Application No. 09/877,311  
Amendment Dated March 31, 2005  
Reply to the Office Action dated November 1, 2004

**Remarks**

FIG. 1

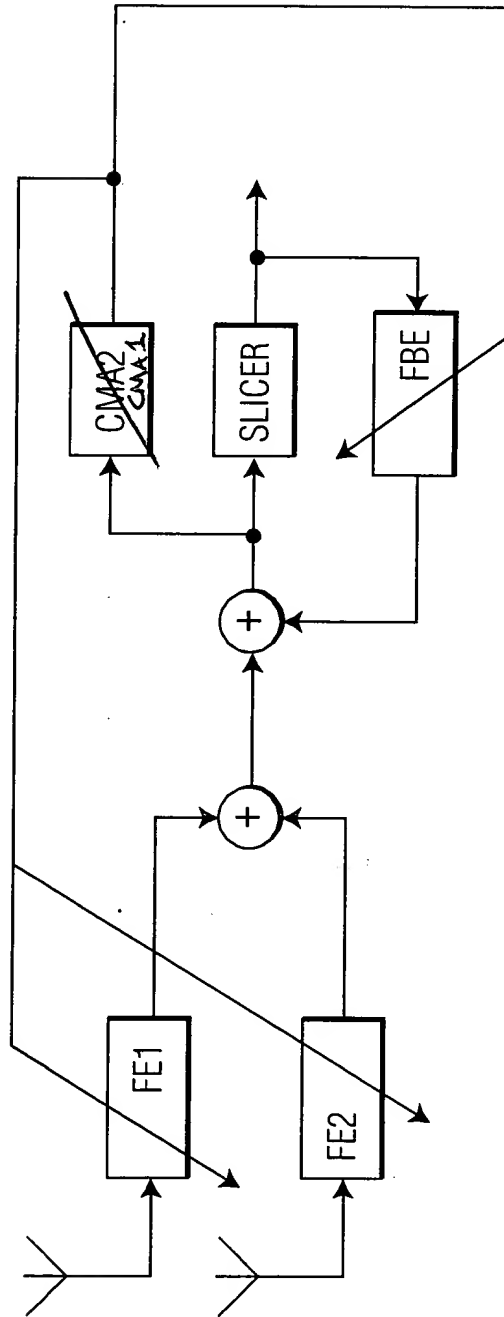
In paragraph 2 of the Office Action, the Examiner has rejected Fig. 1 because it does not show the appropriate description for the element number "CMA1" as described

The attached sheet of drawings includes changes to Fig. 1. This sheet, which includes Fig. 1 replaces the original sheet including Fig. 1. In Fig. 1 the element number "CMA2" was corrected to read "CMA1."

in line 12 on page 6 of the application. Applicants have amended claim 1 accordingly by changing element "CMA2" in original Fig. 1 to read "CMA1."

Applicants note that this change to Fig. 1 is entirely supported by the original application as filed, particularly in the description in the first paragraph on page 6 of the specification. As such, no new matter has been added to this Figure.
